**Flood Control Project Maintenance
Levee Inspections**
LMA District Cover Sheet
Spring 2016 Levee Inspection Results

Reclamation District No. 2058 Pescadero

Levee Inspection Report By Mile - Spring 2016

Waterway	Bank	Unit Miles	Inspection Start/End	Inspector
Unit No. 01 Paradise Cut	Left	6.58	03/22/2016 03/22/2016	Maksim Khashchuk

Photo 2 of 2 : UCIP_SP_2016_45850_74100.jpg

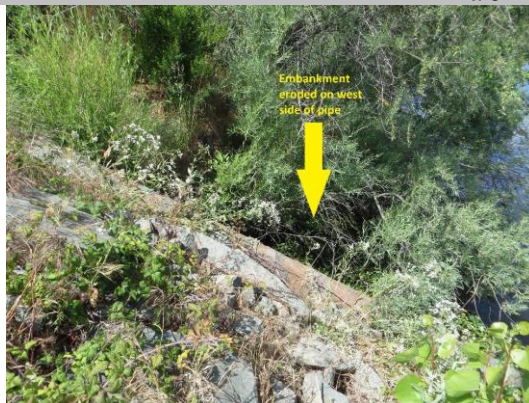
LM Start	1.22	Rating **	U	Issue No.	978 (cont)
LM End	1.22	Issue Type +	En	Location *	LS
Category	Supplemental			GPS Latitude/Longitude	
				Start	End
Item	DWR UCIP Field Study			37.802301 °	37.802301 °
				-121.401977 °	-121.401977 °
DWR ID					
Comment Code					
Inspector Comment					
FS_ID:45850 DS_ID:22694 EP_NO: 11546 Repair Type: Urgent Crossing Status: Found UCIP Comments: Erosion on west side of pipe at W/S toe. FIELD_STRUCT_DESC: 18-inch steel stormdrain pipe through the levee 2-feet below the crown. Pump in ditch on the landward side. Siphon breaker on waterside shoulder. Electrical service pole at the landward toe. Permit No. 11546, 1976. FS Date: 5/13/2015

WS view: slope on west side of pipe eroded at W/S toe. slope on east side of pipe OK.
